INVER GROVE HEIGHTS
PLANNING COMMISSION AGENDA

TUESDAY, FEBRUARY 18, 2020 – 7:00 p.m.
City Council Chambers - 8150 Barbara Avenue

3.01 SOURCE LAND CAPITAL - CASE NO. 20-02PUD

PLANNING REPORT
CITY OF INVER GROVE HEIGHTS

Responsibility Map

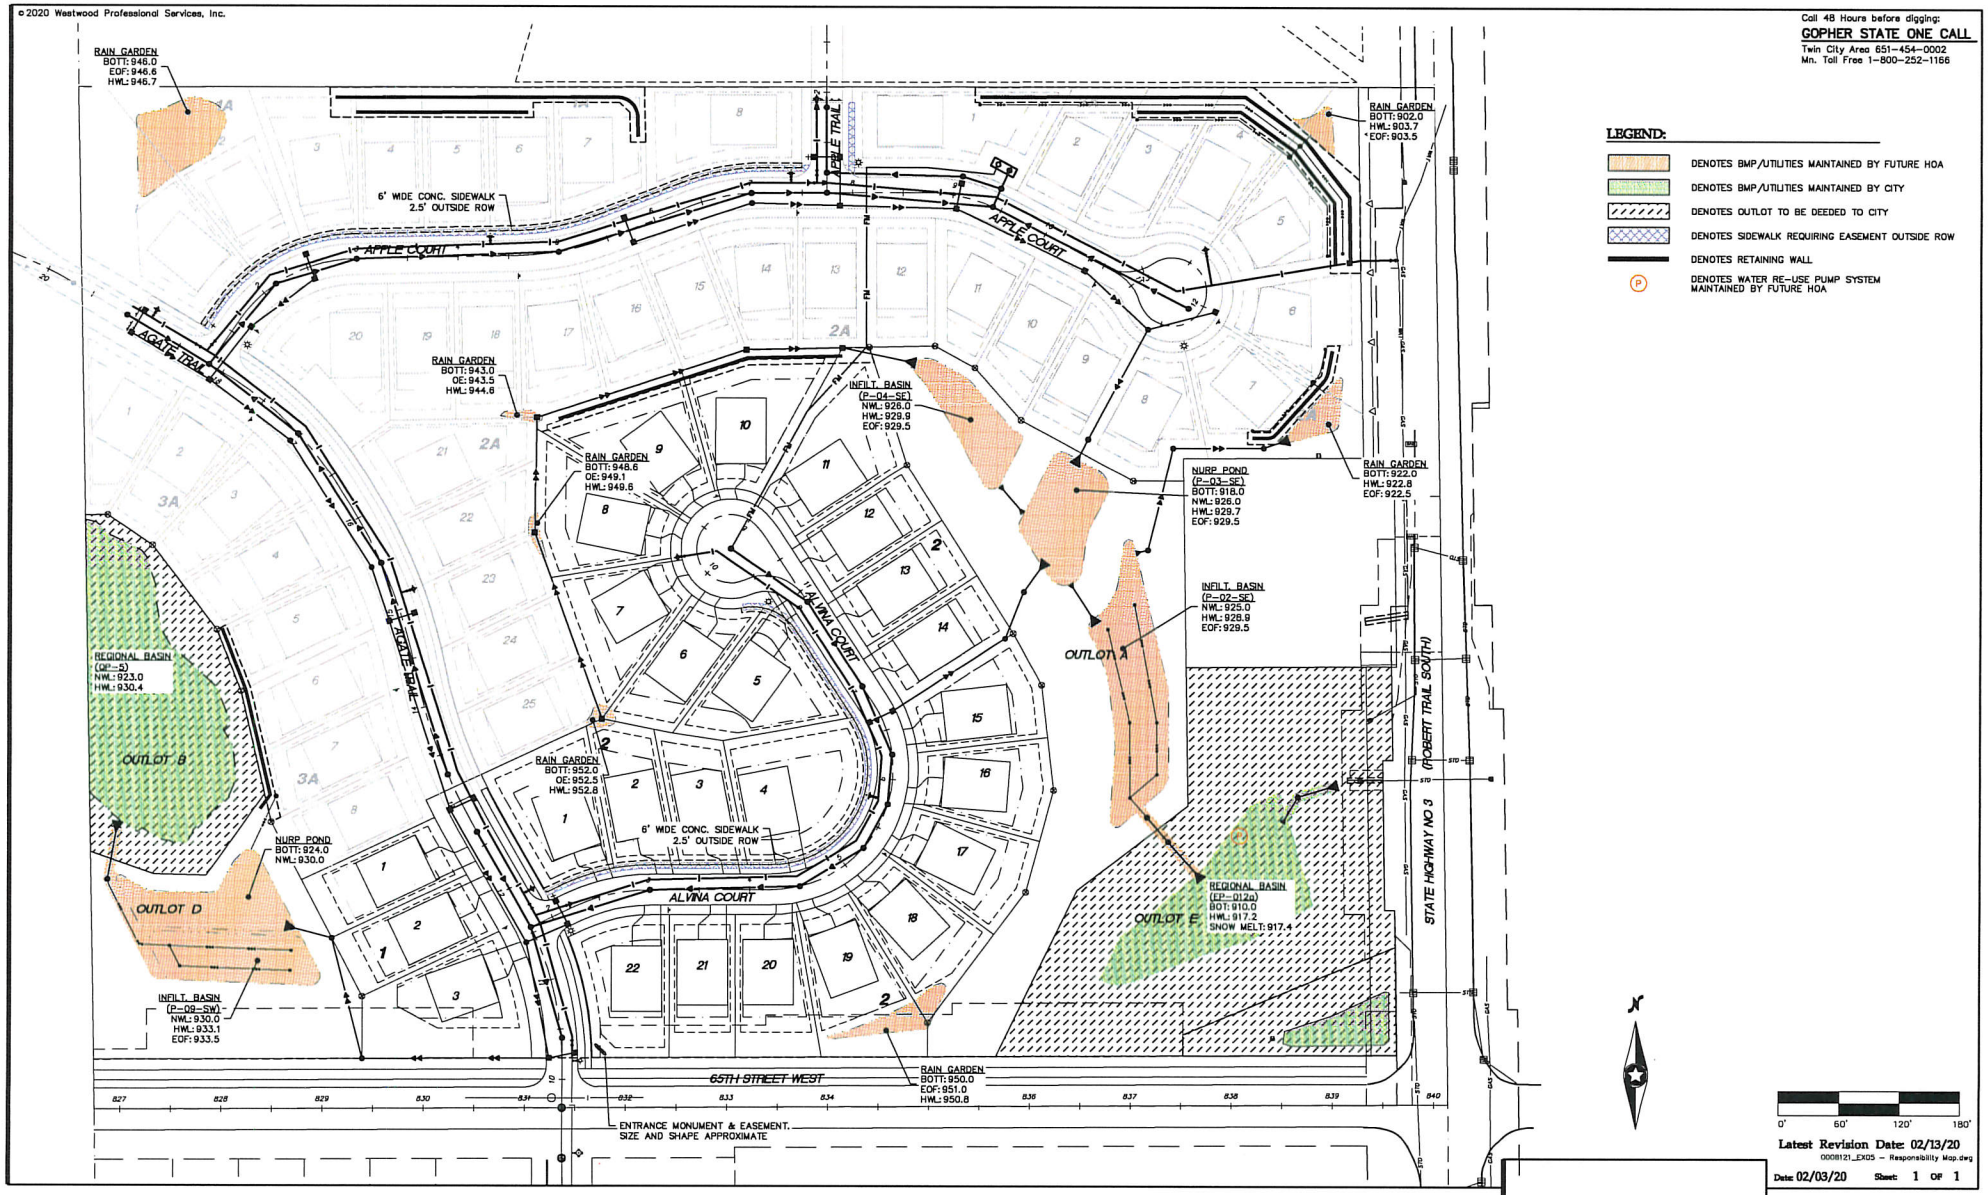
EOR has reviewed the Stormwater Management Plan for S.R.N. to ensure its compliance with the NWA standards. A copy of EOR's approval memo is attached. A summary of stormwater management improvements that have been done at their guidance includes:

1. Stormwater reuse system has been planned and expended for irrigation areas/green spaces in the SE quadrant to account for volumes up through large events (100-year).
2. The SW area has had soil borings done to identify infiltratable soils, the infiltration systems, and pretreatment basin have been reconfigured to promote more infiltration using the good soils.
3. Soil borings were taken throughout the proposed project and stormwater facilities to confirm and resize the distributed stormwater facilities (rain gardens, infiltration systems, and stormwater reuse systems) based on the additional soil investigations/borings.
4. The overflow and stormwater distribution systems/locations were further refined. The plan adjusted the overflow to the northeast to better balance the runoff volumes for the range of events.

Grading & Erosion Control Plan

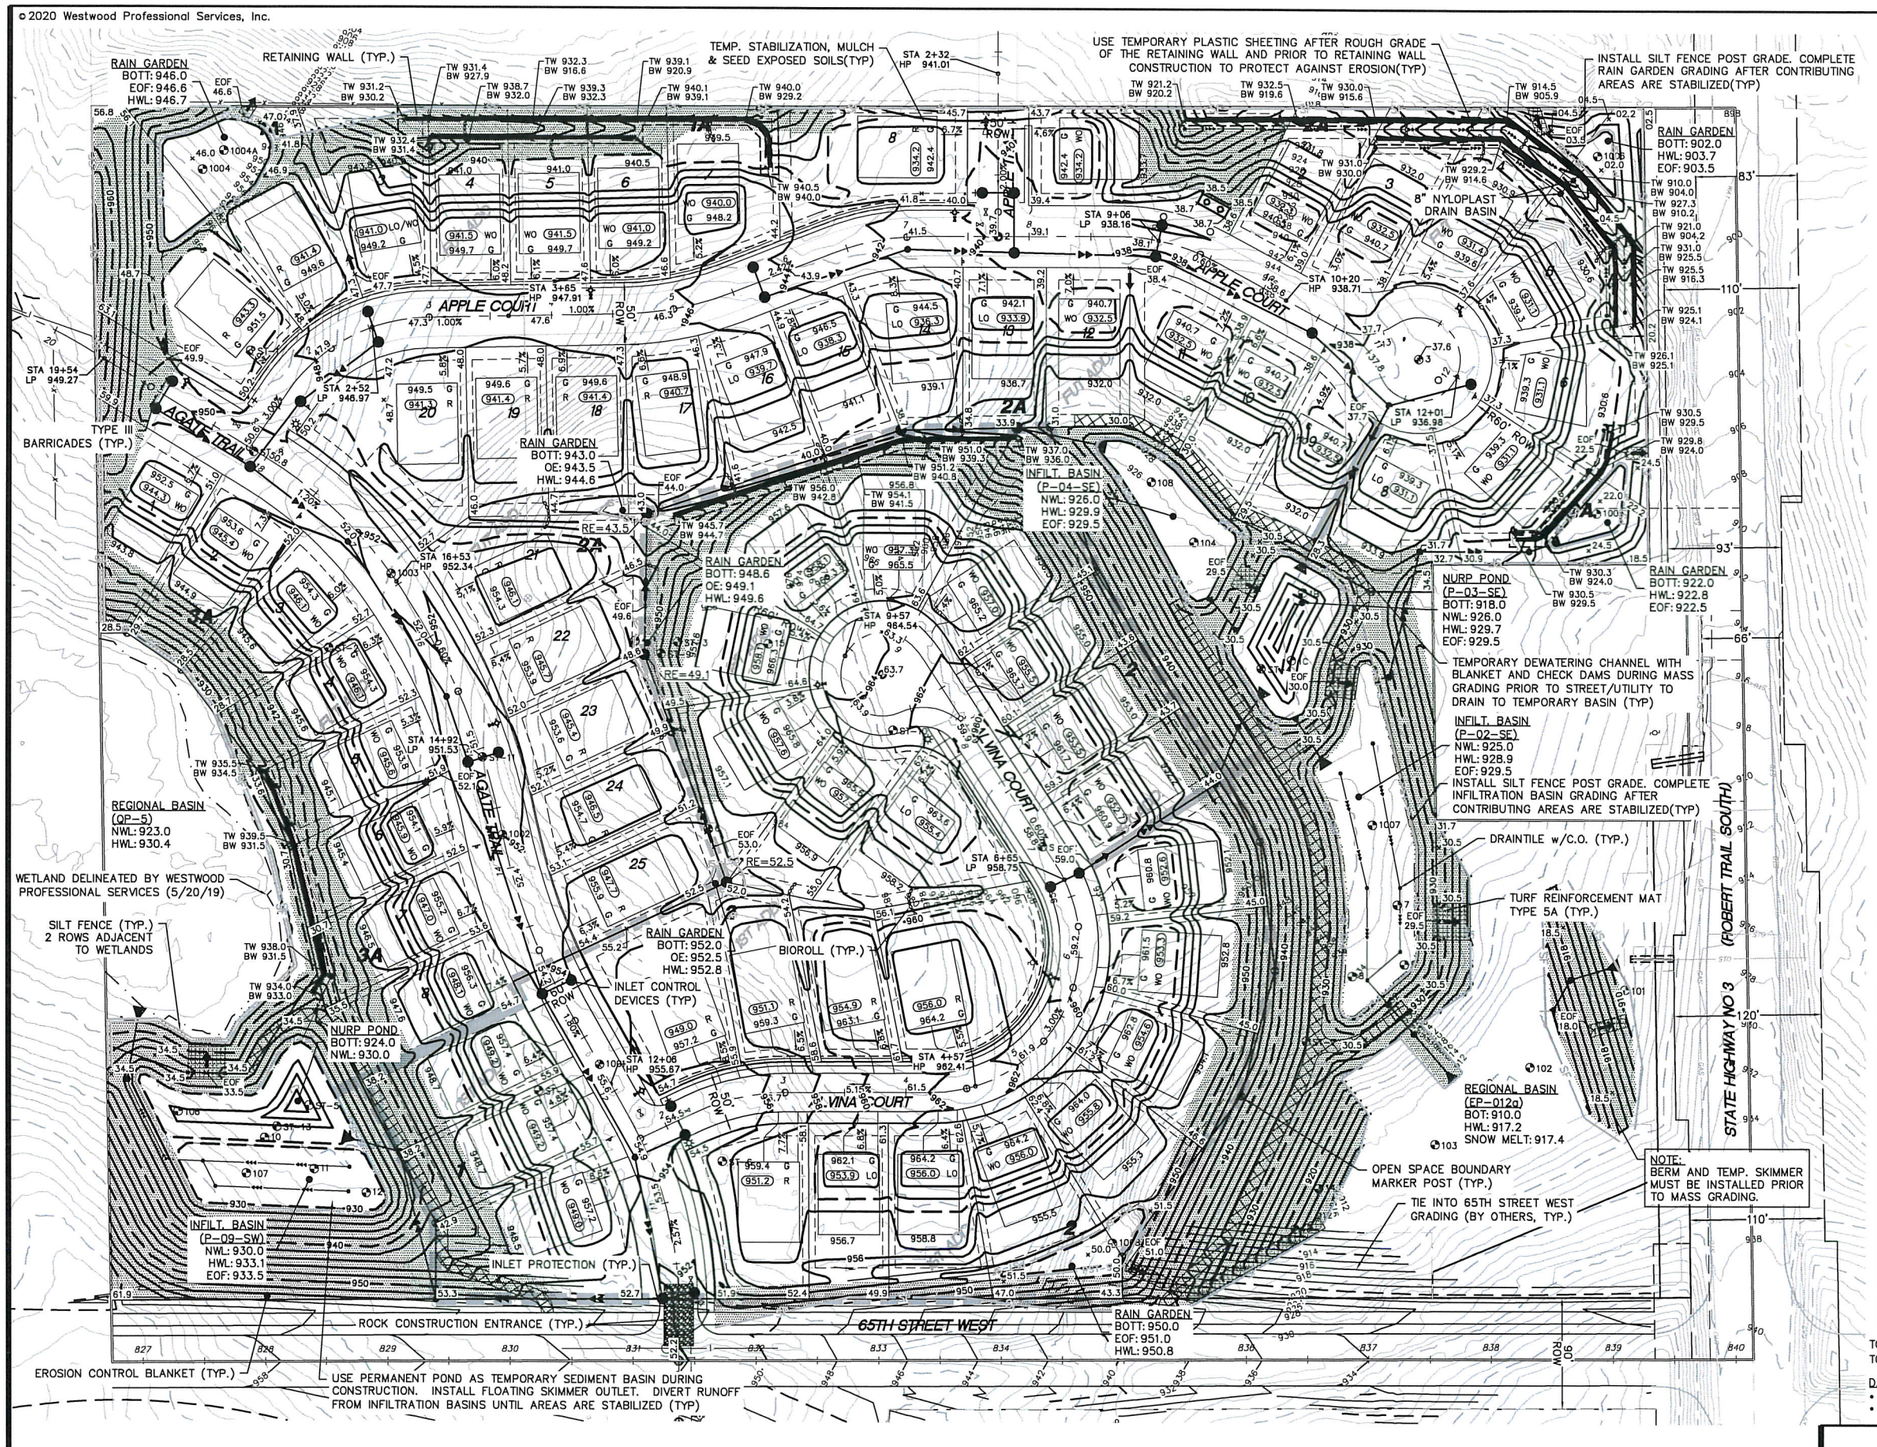
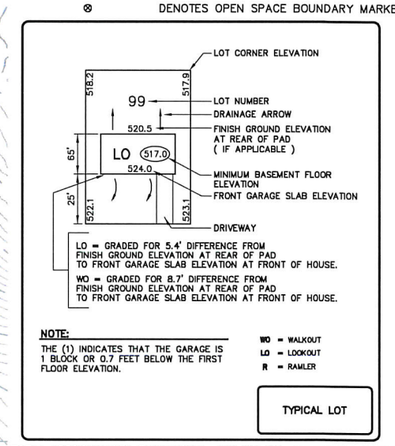
Condition #4 relating to boundaries of open space with marker posts. Engineering has created a post and sign template for developers to use to mark the open space boundary. The grading plan identifies the proposed location of the posts. The final location of the posts will be approved by Engineering and will be field inspected.

3. Land covers for several catchments include areas of amended soils. Submit a soil amendment and restoration specification so that proposed CN value can be confirmed.
4. Show areas of proposed soil amendment on the Erosion Control and Restorations Plans.
